## BEACON HILL JSP15-08

Public hearing at the request of The Ivanhoe Companies for Planning Commission approval of the Preliminary Site Plan with Site Condominium, Phasing Plan, Wetland Permit, Woodland Permit, and Storm water Management Plan. The subject property is currently R-4 (One-Family Residential) and B-3 (General Business) with a Planned Rezoning Overlay Agreement .The subject property is approximately 21.13-acres and is located on the northeast corner of Twelve Mile Road and Meadowbrook Road (Section 12). The applicant is proposing a 39 unit single family residential development, 10,500 square feet of commercial space, and an open space/park.

## PLANNING REVIEW

**PRO AND PHASING PLAN**  
 BEACON HILL PARK  
 NOV, MICHIGAN, SECTION 12

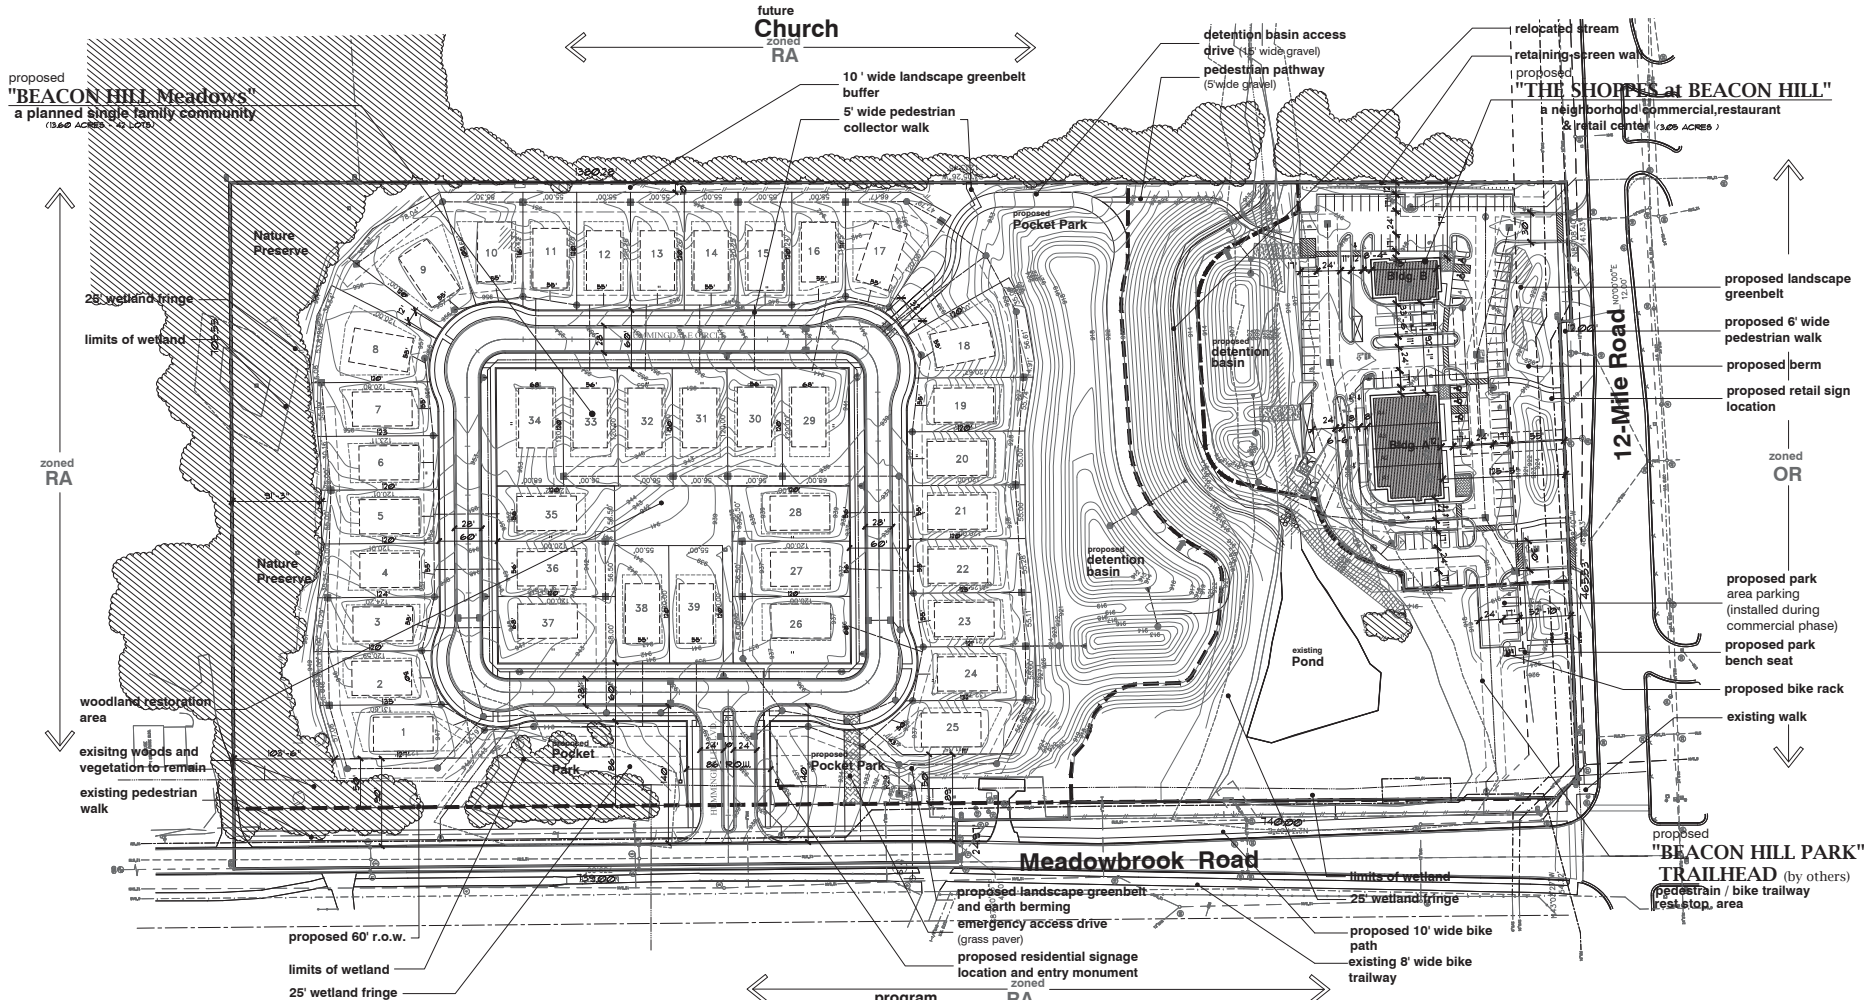
| Item   | Required Code  | Proposed  | Meets Code | Comments   |
|--|--|---|------------|--|
|  |  | Phase 2: Complete Commercial and complete Park trailhead  |            | <b>Number of residential units on sheet SP-5 is incorrect. Please change it to 39 units.</b>   |
